**P & ID
STANDBY LIQUID
CONTROL (SC)**
H. H. ZIMMER NUCLEAR POWER STATION UNIT I
THE CINCINNATI GAS & ELECTRIC CO.
COLUMBUS & SOUTHERN OHIO ELECTRIC CO.
THE DAYTON POWER & LIGHT CO.

SARGENT & LUNDY
ENGINEERS
CHICAGO
DRAWING NO.
M-57
SHEET 1 OF 1

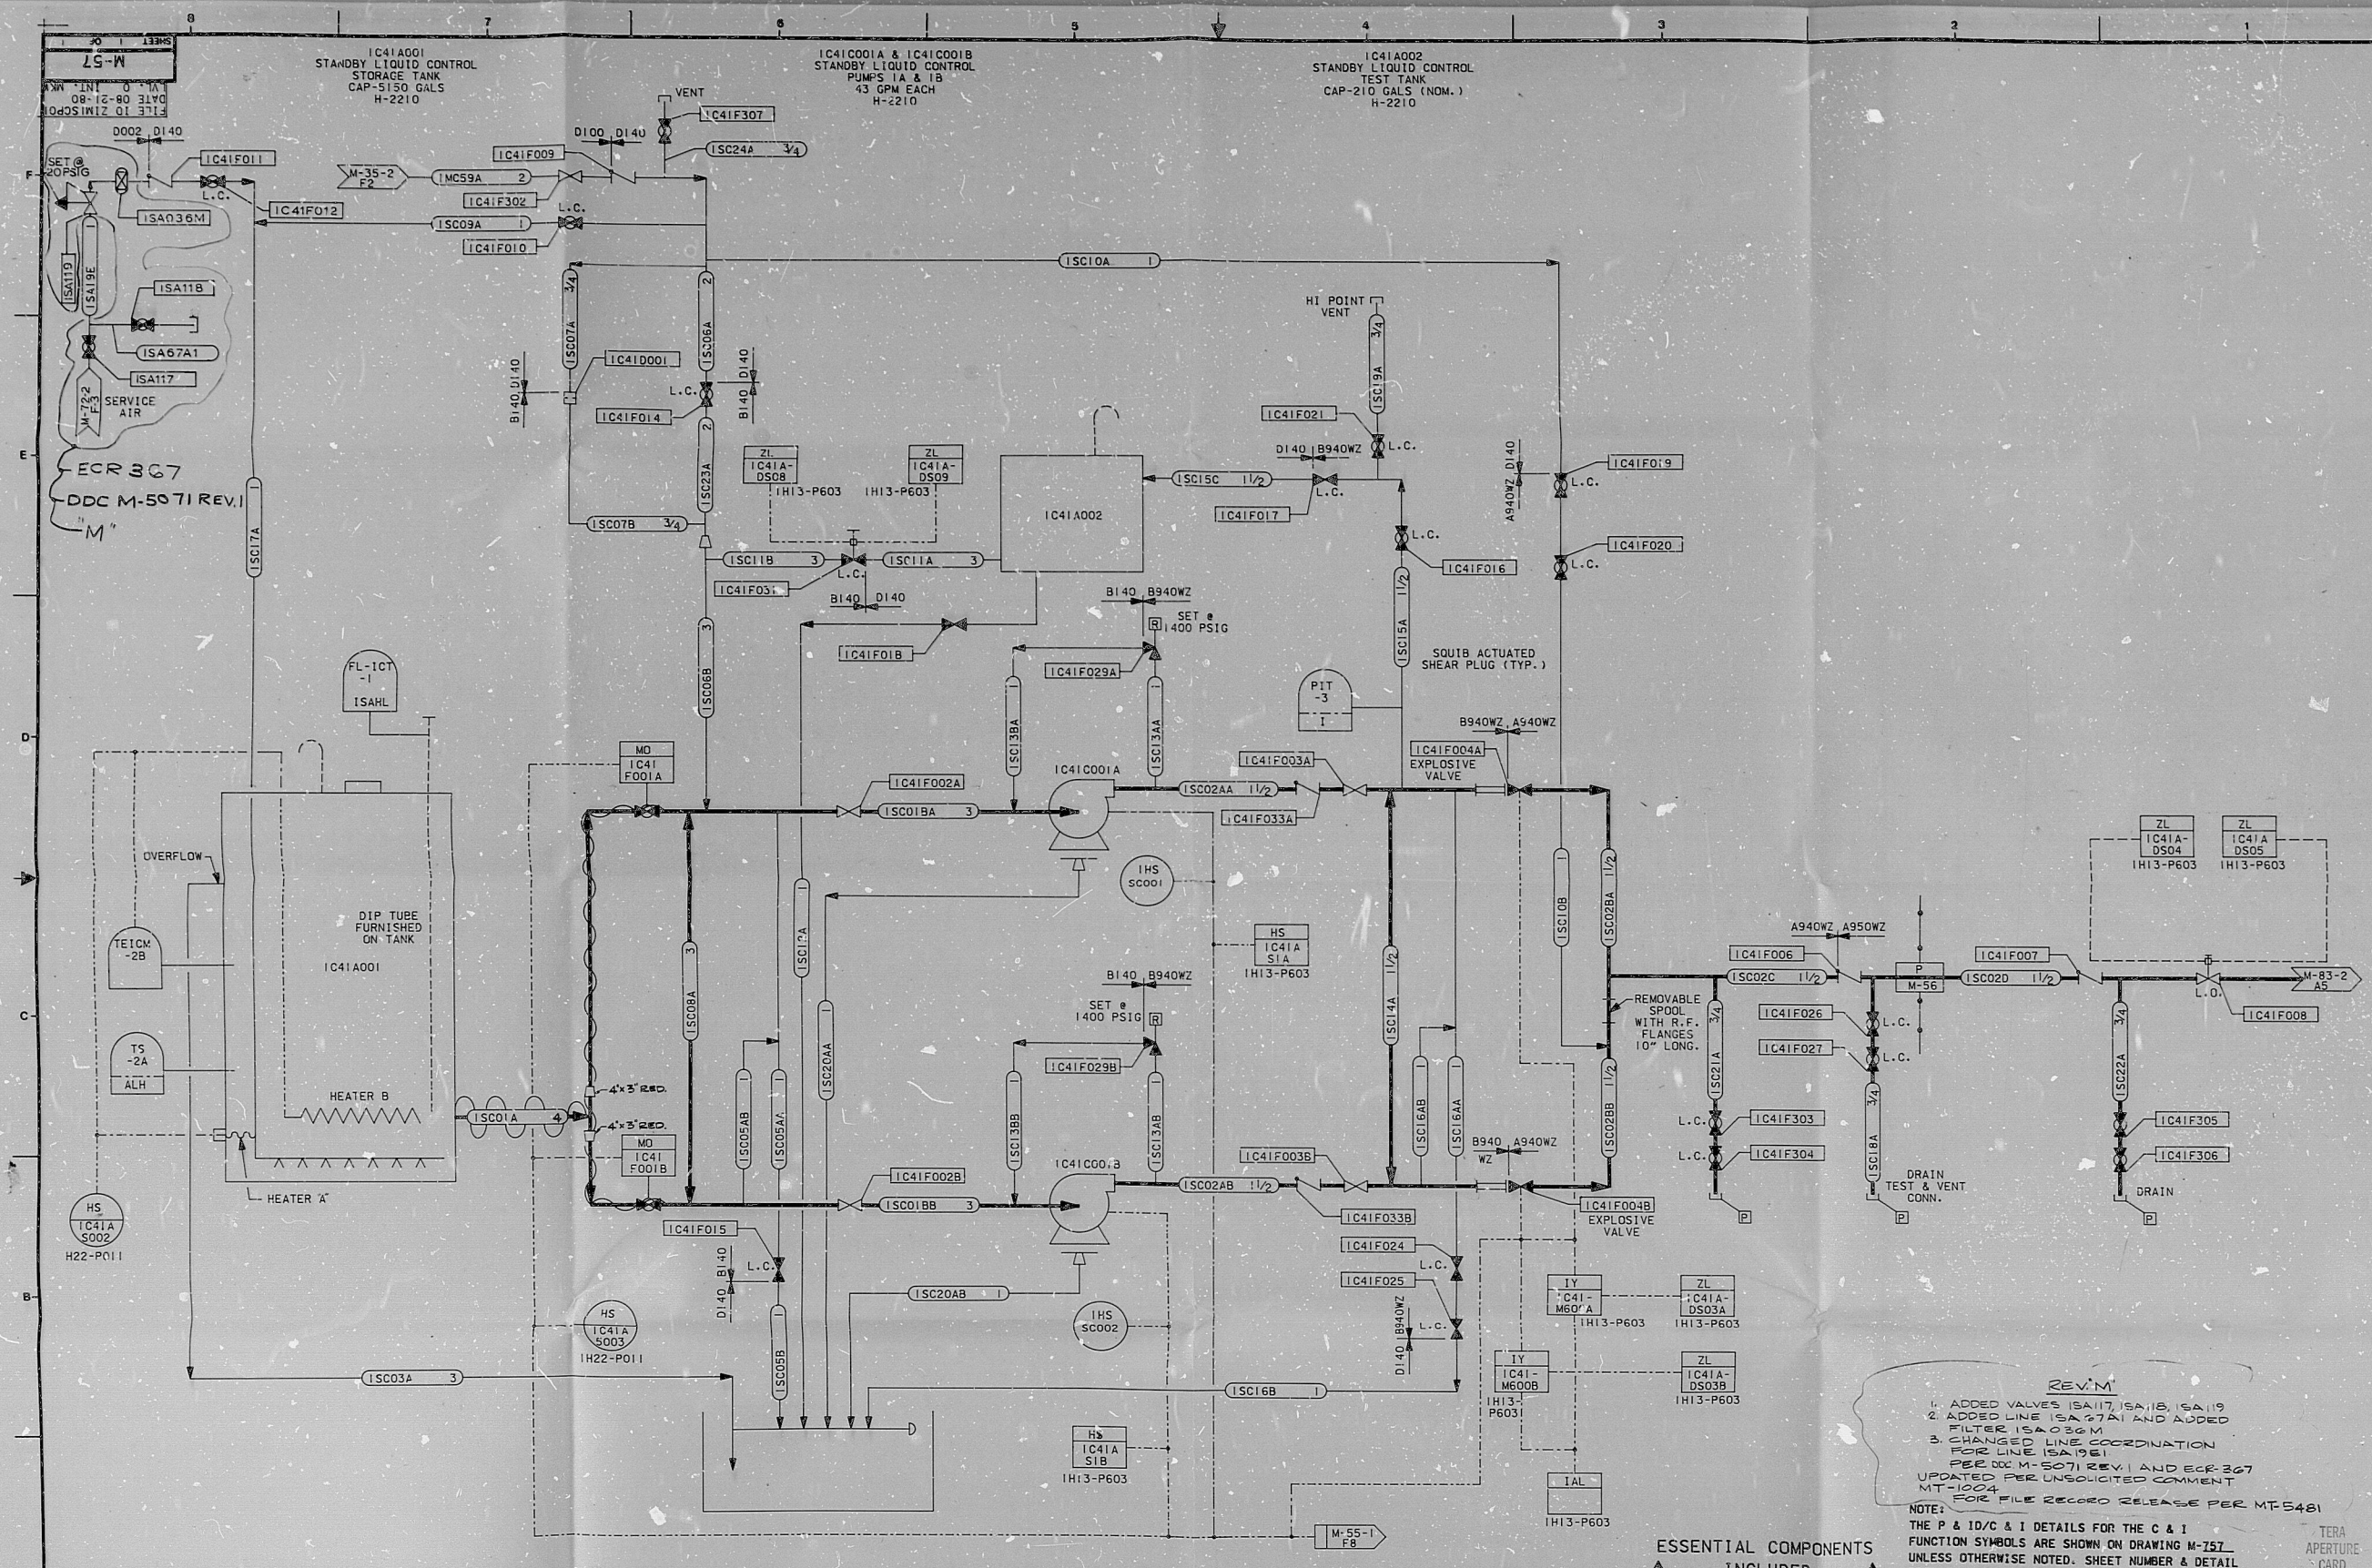
REV. M
1. ADDED VALVES ISA117, ISA118, ISA119
2. ADDED LINE ISA27A1 AND ADDED
FILTER ISA036M
3. CHANGED LINE COORDINATION
FOR LINE ISA1961
PER M-5071 REV. I AND ECR-367
UPDATED PER UNSOLICITED COMMENT
MT-1004
FOR FILE RECORD RELEASE PER MT-5481
